Access Compliance Report

Public Rights-of-Way

Intersection ID: 12089	Main Street: E_12TH_ST	Cross Street: N_DAVIDSON_ST	Location: N
ADA ID: 7F0E896B8B4C	Ramp Type: PerpDiag	Initial Pass/Fail: Fail	Overall Compliance: No
Severity Score: 46.25			
Codes/Mitigation Info/Possible Solution		Field Measurements/Component Compliance

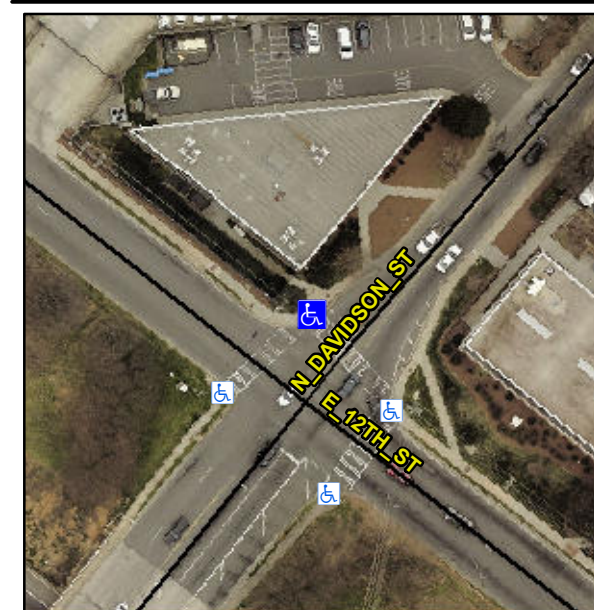
Not Found, R304.5.1, R304.2.2, R304.5.3

Compliance	Description	Data	Compliance	Description	Data
N/A	Ramp Length (in)	61.0	No	Ramp Slope (%)	13.2
No	Ramp Width (in)	47.0	No	Ramp XSlope (%)	5.9
N/A	Flare Type LT	N/A	N/A	Flare Type RT	N/A
N/A	Flare Slope LT (%)	N/A	N/A	Flare Slope RT (%)	N/A
N/A	Flare Traversable LT?	N/A	N/A	Flare Traversable RT?	N/A
N/A	Landing Length (in)	N/A	N/A	DWS Provided?	N/A
N/A	Landing Width (in)	N/A	N/A	DWS Contrast?	N/A
N/A	Landing Slope (%)	N/A	N/A	DWS Length (in)	N/A
N/A	Landing X Slope (%)	N/A	N/A	DWS Full Width?	N/A
N/A	Landing Curb? (Y/N)	N/A	N/A	DWS Offset (in)	N/A
N/A	Shared Landing?	N/A			
N/A	Gutter Ponding?	N/A	N/A	Gutter Slope (%)	N/A
N/A	Gutter Lip Ht (in)	3.0	N/A	Gutter X Slope (%)	N/A
N/A	Painted X Walk1?	Yes	N/A	Painted X Walk2?	Yes
	X Walk 1 Direction	To SW		X Walk 2 Direction	To SE
N/A	X Walk 1 Width (in)	143.0	N/A	X Walk 2 Width (in)	112.0
	X Walk 1 Slope (%)	2.3		X Walk 2 Slope (%)	6.4
	X Walk 1 X Slope (%)	8.3		X Walk 2 X Slope (%)	3.5

Remove & Replace Curb Ramp With Two New Directional Ramps or Equivalent.
